PLANNING COMMISSION

STAFF REPORT

MEETING DATE:	March 26, 2025
PROJECT:	Consideration of approval of an Initial Master Plan for seven contiguous parcels located Southwest of the intersection of Buckwalter Parkway and Bluffton Parkway within the Buckwalter Planned Unit Development consisting of 114.55 acres that will include 21.7 acres upland acres of commercial/mixed use development and 47.0 upland acres of medical/commercial development.
PROJECT MANAGER:	Dan Frazier, AICP Planning Manager Department of Growth Management

REQUEST: A request for approval of an Initial Master Plan application for Parkway Corners within the Buckwalter Planned Unit Development (Attachments 1 and 2).

Buckwalter PUD Concept Master Plan

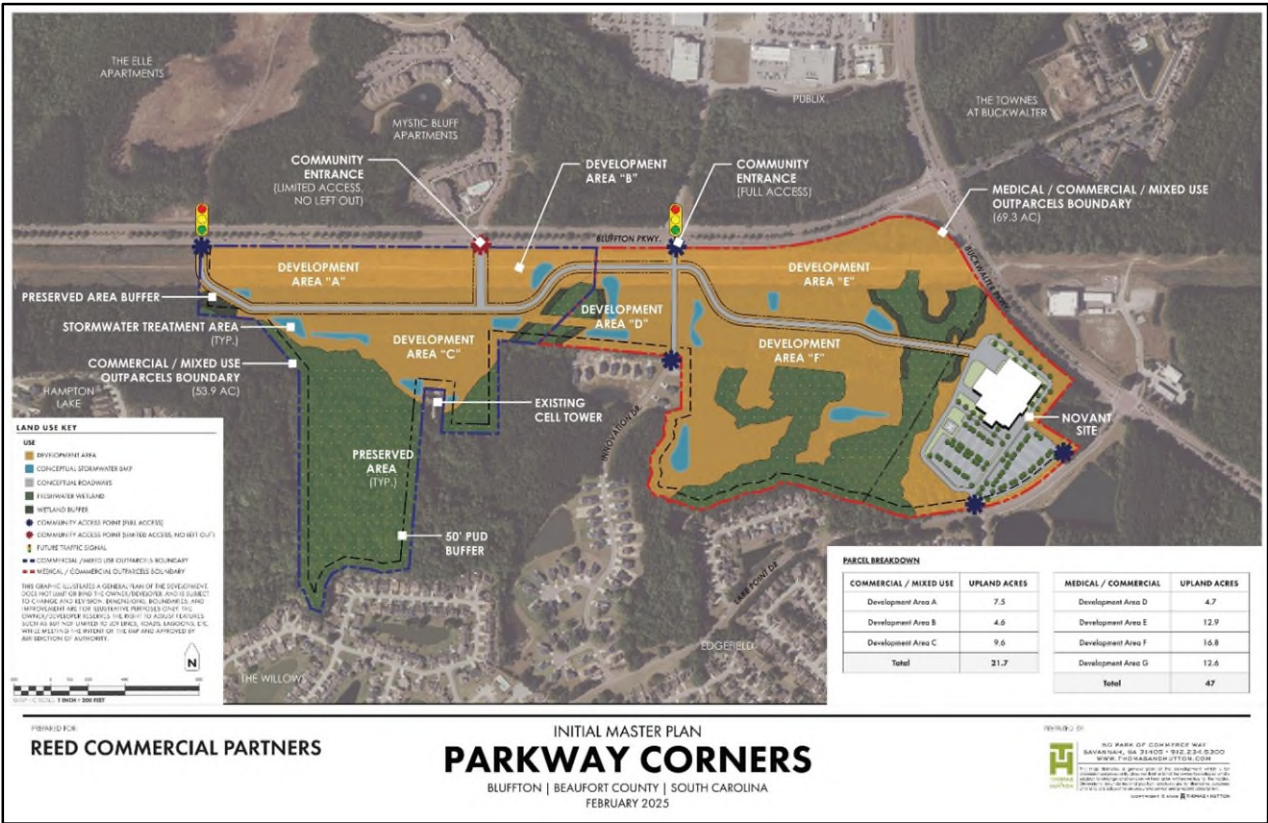
Finding. The application is not consistent with the provisions of the Buckwalter PUD Concept Plan.

The proposed Initial Master Plan and Conceptual Plan (Attachments 4 and 5) are not consistent with the Buckwalter PUD Concept Plan (Attachment 3). The Buckwalter PUD Concept Plan identifies a future realignment of the portion of the Bluffton Parkway west of Buckwalter Parkway that is not reflected on either the Initial Master Plan or Concept Plan.

1. All Plan Exhibits, including the Initial Master Plan and Concept Plan, shall be updated to identify a future realignment of the portion of the Bluffton Parkway west of Buckwalter Parkway.
2. At time of development permit applications, any proposed development that substantially deviates from the approved Initial Master Plan or Conceptual Plan, as determined by the UDO Administrator, may warrant a minor or major amendment to the Master Plan document.
3. Provide updated will-serve letters as part of the Initial Master Plan Application.
